The Naiad Frigate Addendum 6 – Jogging Cant Frames

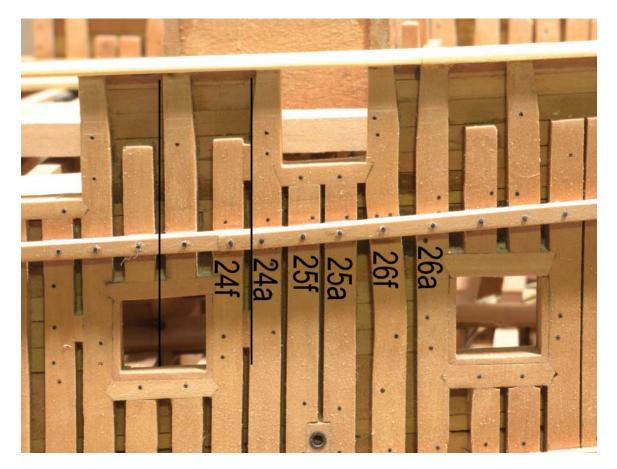
Square frame patterns contain notes on the jogging of the top timbers to align precisely with the gun port sides. Cant frames do not include this information, requiring some attention when setting these to ensure that the upper futtocks frame the ports accurately. This should not be an issue on the large carronade ports, but the aftermost 9-pounder ports require jogging of the upper futtocks on frame 26f to frames these smaller ports accurately.

The photo below shows the jogging forward at the top of frame 26f on the finished model.

This is the only cant frame requiring this. For the two aftermost carronade ports, precise locations are shown for the upper frames on drawing 2 and 2B. These locations are used to set the cant frames so the carronade ports will be sized correctly.
